IC-7000 60 Meter Modification

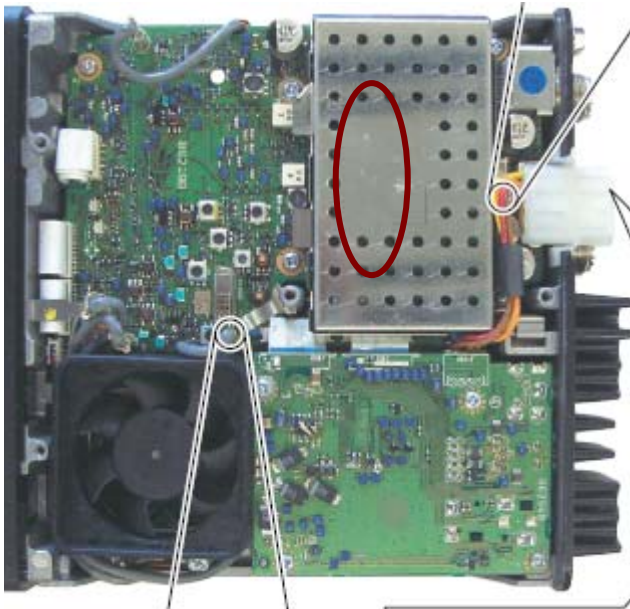
Removing D2172 diode on the Main board opens the radio up to all of the 60 meter frequencies, including frequencies not allowed by the FCC.

Main Board Layout

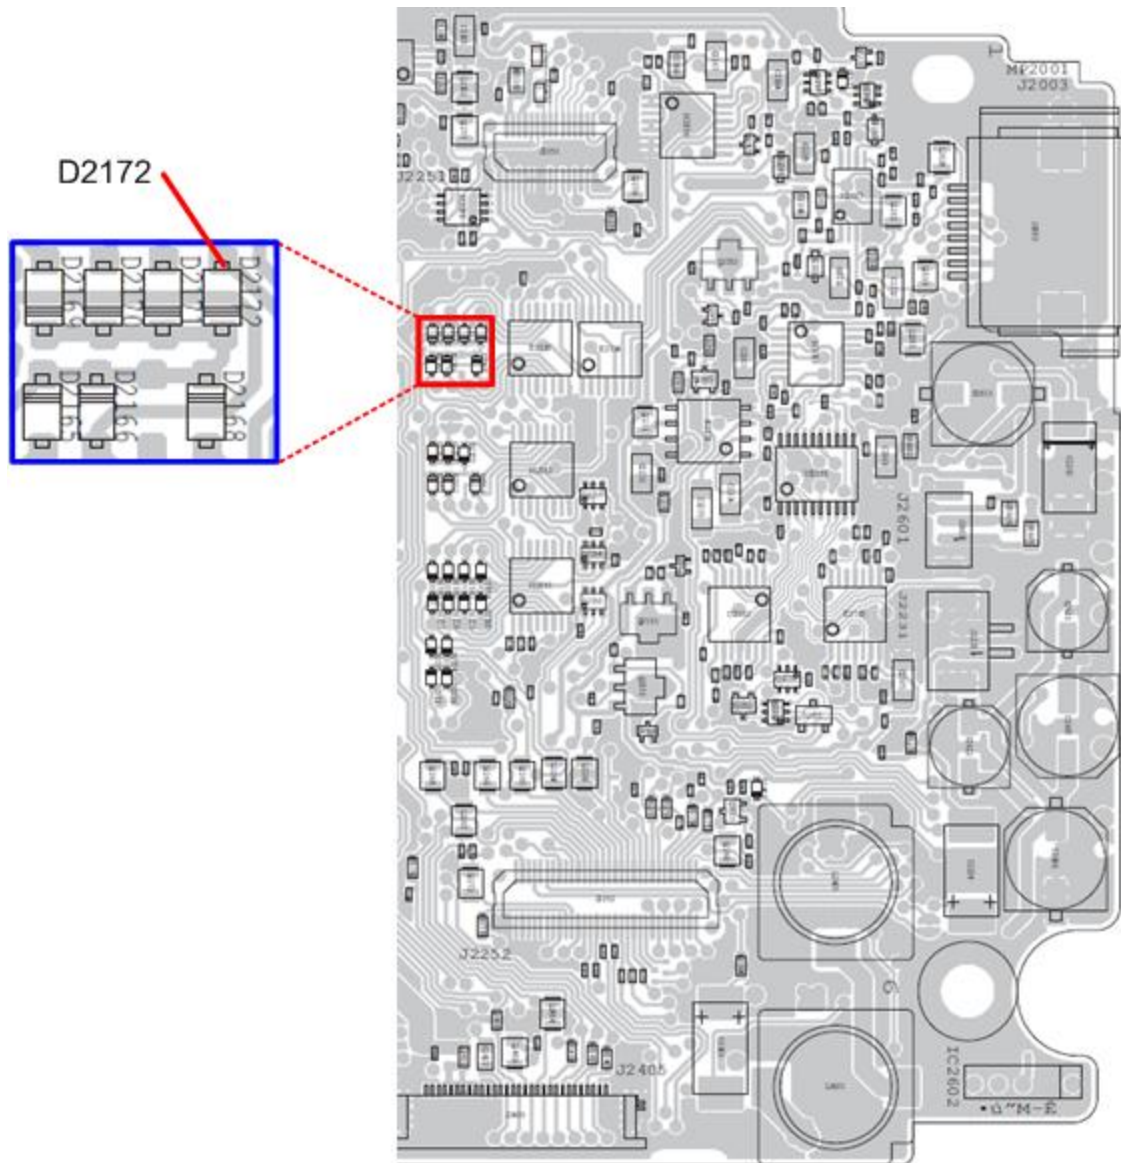
1. Remove shield. The diode matrix on the main board is located under the metal shield. Good SMT (Surface Mount Technology) techniques must be used to remove the diode.

2. Remove D2172.
3. Reinstall the Shield and reassemble the radio.
